UNTIL SUCH TIME AS THESE DRAWINGS ARE APPROVED BY THE AGENCIES, OR ENGINEERING APPROVES THEIR USE, THESE DRAWINGS ARE DESIGNATED BY WRITTEN AUTHORIZATION.	
PREPARED FOR	SR LAND, LLC 20 BOULDER CRESCENT SUITE 201 COLORADO SPRINGS, CO 80903 JAMES F. MORLEY (719) 471-1742
J.R. ENGINEERING A Western Company Central 303-740-9888 • Colorado Springs 719-583-2583 Fort Collins 970-491-9888 • www.jrengineering.com	
BY	DATE
REVISION	
No.	
1"=50'	N/A
H-SCALE	DATE
V-SCALE	09/10/21
DESIGNED BY	AAM
DRAWN BY	CJD
CHECKED BY	
STERLING RANCH PHASE 2 PRELIMINARY GRADING PLAN	
SHEET 6 OF 17	
JOB NO. 25188.02

STERLING RANCH PHASE 2
PRELIMINARY GRADING PLAN

V1_Grading Plan.pdf Markup Summary

STERLING RANCH PHASE 2	H-SCALE 1"=50'		V-SCALE	N/A	No.	REVISION	BY	DATE
	DESIGNED BY		AAM					
	DRAWN BY		CJD					
	CHECKED BY							
PRELIMINARY GRADING PLAN								
SHEET 8 OF 17								
JOB NO. 25188.02

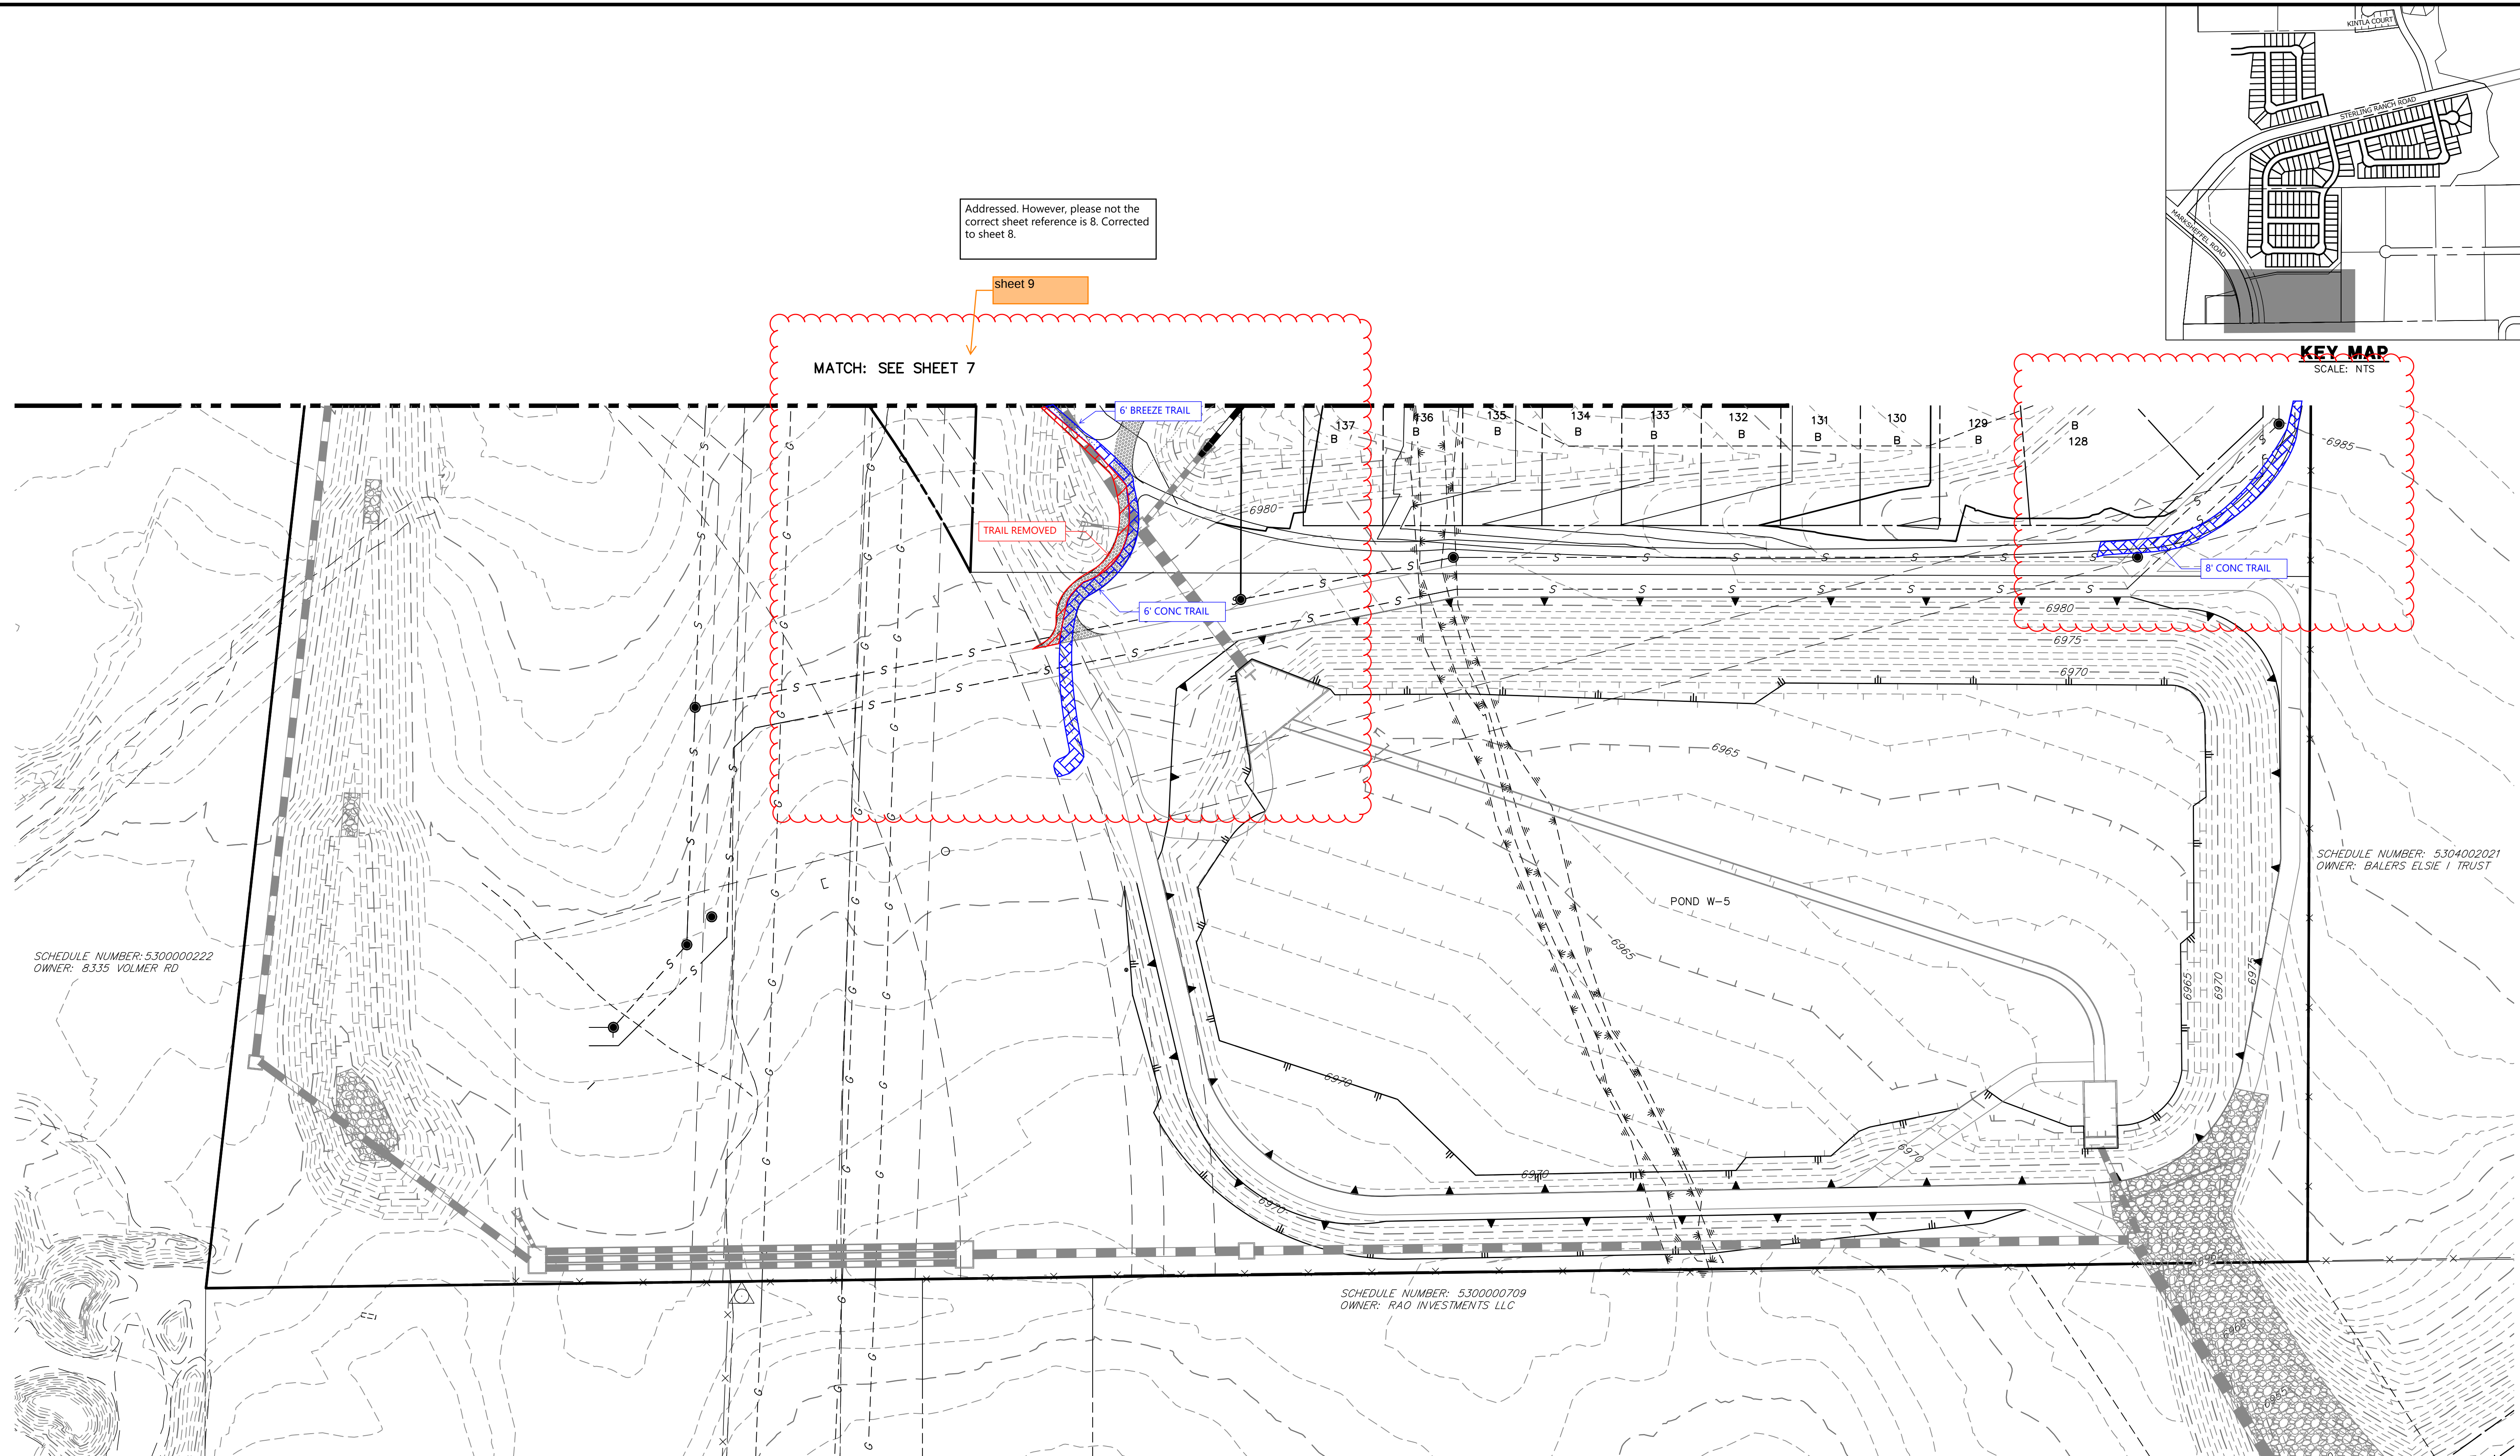
MATCH: SEE SHEET 7

sheet 9

Addressed. However, please not the correct sheet reference is 8. Corrected to sheet 8.
